HERNE BAY COLLECTOR
T&T-HBC-RPT-00008_3

HBC MH02 SHAFT RELOCATION S127 GROUNDWATER AND SETTLEMENT ASSESSMENT

Herne Bay Collector s127 application for relocation of Shaft MH02 Groundwater and settlement effects assessment

Herne Bay - MH02 Relocation
Section A-B

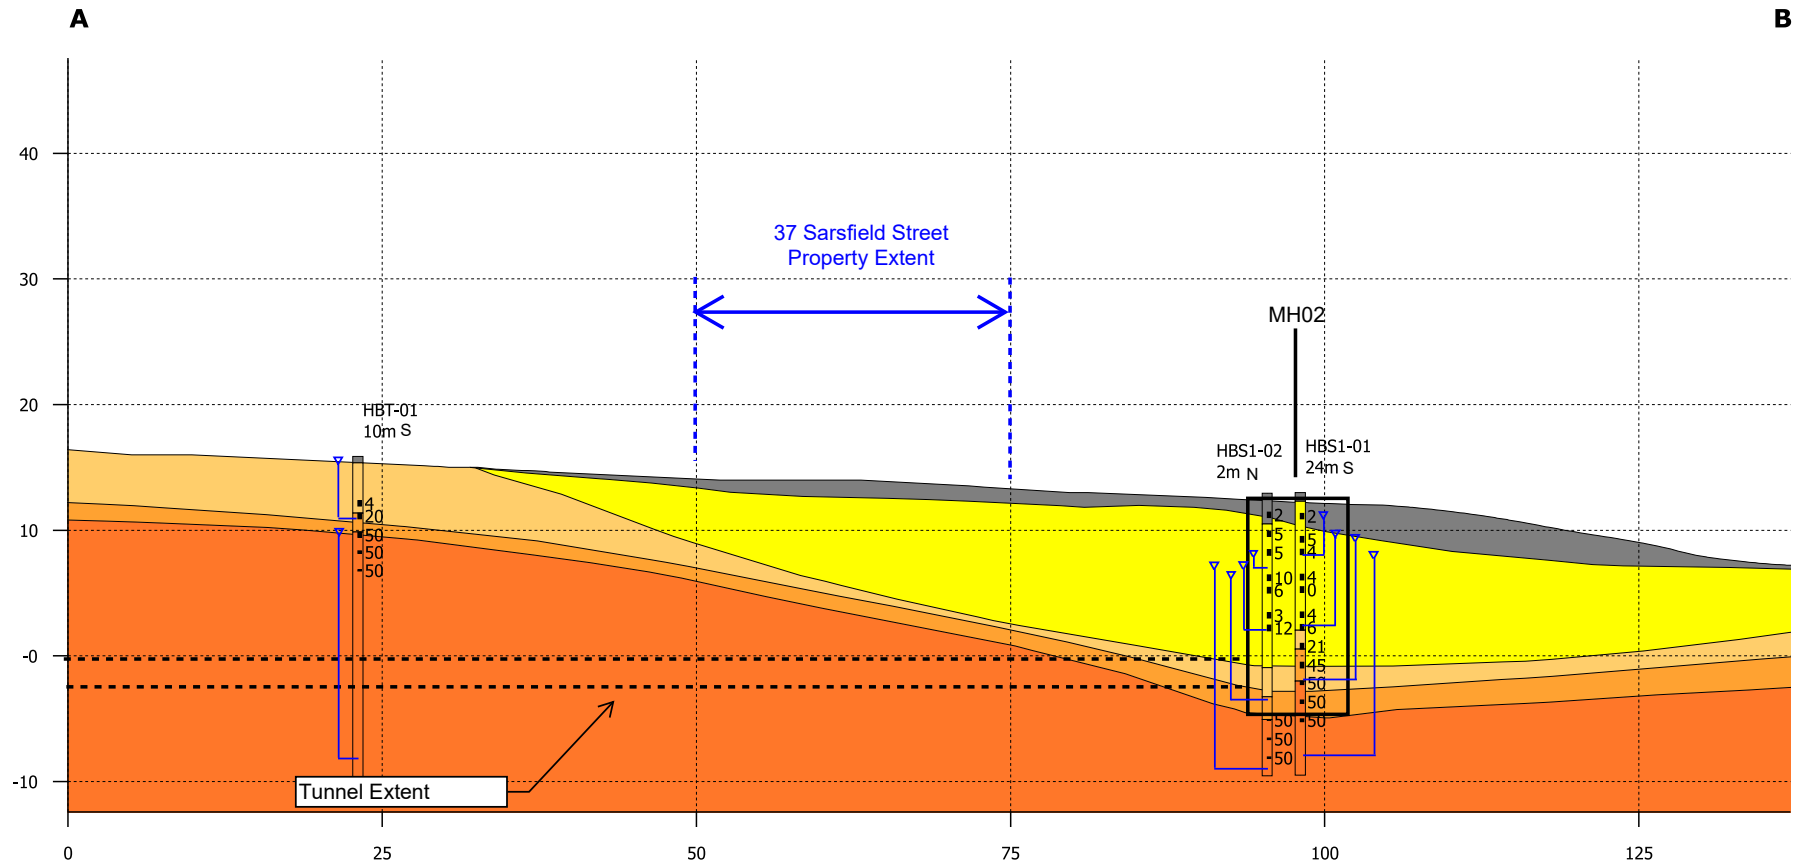
4	Please confirm how the ground model presented in geological long-section A-B was determined and update the section and Figure 1 with relevant boreholes and provide the logs in an Appendix. In addition, please provide the measured ground water levels on the long -section. This is important because the long-section indicates that the tunnel is wholly within ECBF rock under the property at 37 Sarsfield. It is expected that the findings of a machine borehole on Sarsfield Street outside 37 Sarsfield Street (or nearby) which informs the depth and thickness of the Takanini Formation that is shown on the long section A-B will be provided.	Appendix A Figure 2 & Figure 3.
5	The settlement profile presented in Figure 2.1 in “The s127 T & T Report” titled “Estimated combined settlement profile due to main shaft excavation (September 2023 GSEA)” appears to be slightly different from Figure 8.1 in the “Herne Bay Connector Project – Groundwater and Settlement Assessment Report,” prepared by T & T, dated 27 September 2023, Job no. 1090120.0000 v4. Please provide clarification.	No changes
